# Intel<sup>®</sup> Pentium<sup>®</sup> 4 Processor Specification Update

Release Date: January 2002

Order Number: 249199-018

The following figure will be added as Figure (new). THERMTRIP# Power Down Sequence

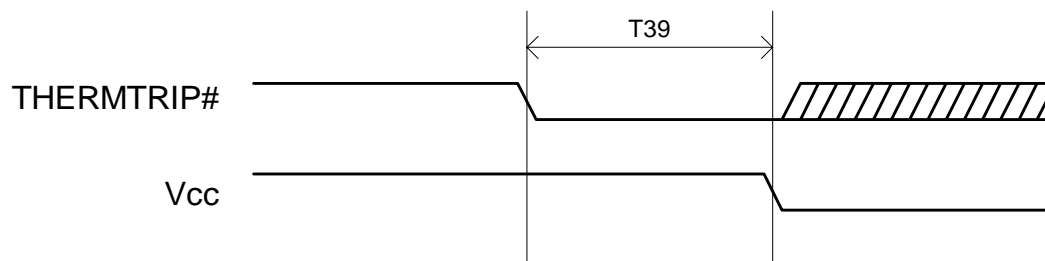
Several parts of the *Intel® Pentium® 4 Processor in the 423-pin Package* datasheet will be updated as follows to clarify the functionality of the Thermtrip# pin.

The description of THERMTRIP# in Table 32, page 69 will now state:

Assertion of THERMTRIP# (Thermal Trip) indicates the processor junction temperature has reached a level beyond which permanent silicon damage may occur. Measurement of the temperature is accomplished through an internal thermal sensor which is configured to trip at approximately 135°C. Upon assertion of THERMTRIP#, the processor will shut off its internal clocks (thus halting program execution) in an attempt to reduce the processor junction temperature. To protect the processor, its core voltage ( $V_{CC}$ ) must be removed following the assertion of THERMTRIP#. See Figure (new) and Table 13 for the appropriate power down sequence and timing requirements. Once activated, THERMTRIP# remains latched until RESET# is asserted. While the assertion of the RESET# signal will de-assert THERMTRIP# , if the processor's junction temperature remains at or above the trip level, THERMTRIP# will again be asserted after RESET# is de-asserted.

The following specification will be added to Table 13, page 24.

<u>T# Parameter</u>	<u>Min</u>	<u>Max</u>	<u>Unit</u>	<u>Figure</u>	<u>Notes</u>
T39: THERMTRIP# to removal of power	N/A	500	ms	(new)
